MIL-C-38271A
AMENDMENT 4
11 DECEMBER 1992
SUPERSEDING
AMENDMENT 3
1 June 1982

MILITARY SPECIFICATION

CONNECTOR, OXYGEN MASK TO REGULATOR CRU-60/F

This amendment forms a part of MIL-C-38271A, dated 11 March 1968 and is approved for use by all Departments and Agencies of the Department of Defense.

FIGURE 6 MASK PORT

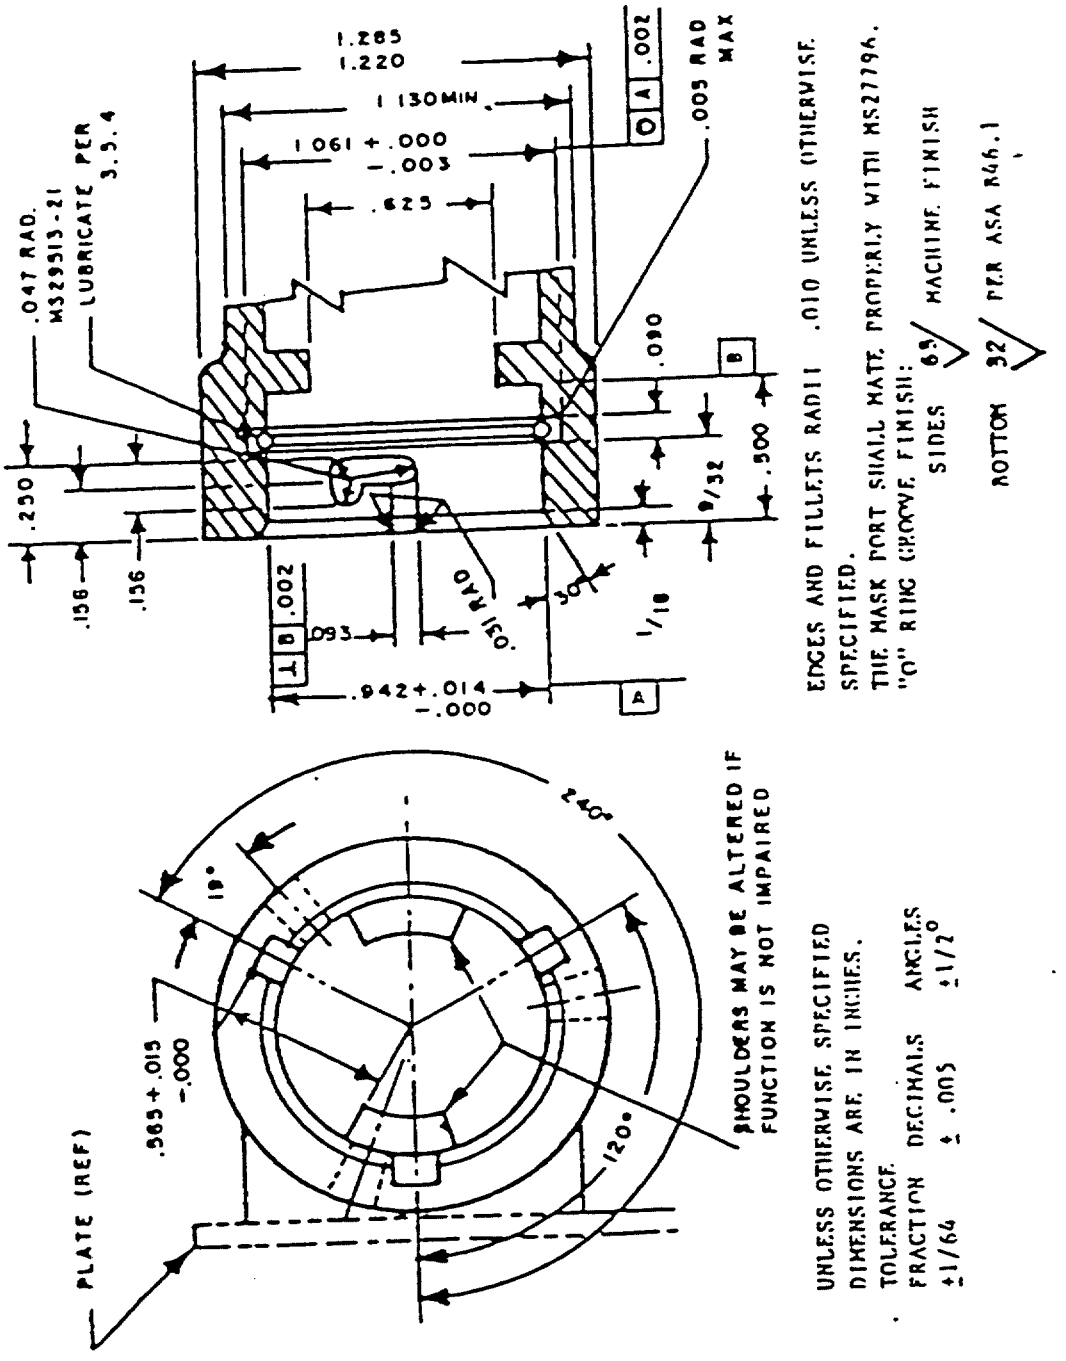
Figure 6: Delete and substitute Figure 6 as shown on Page 3 of this amendment.
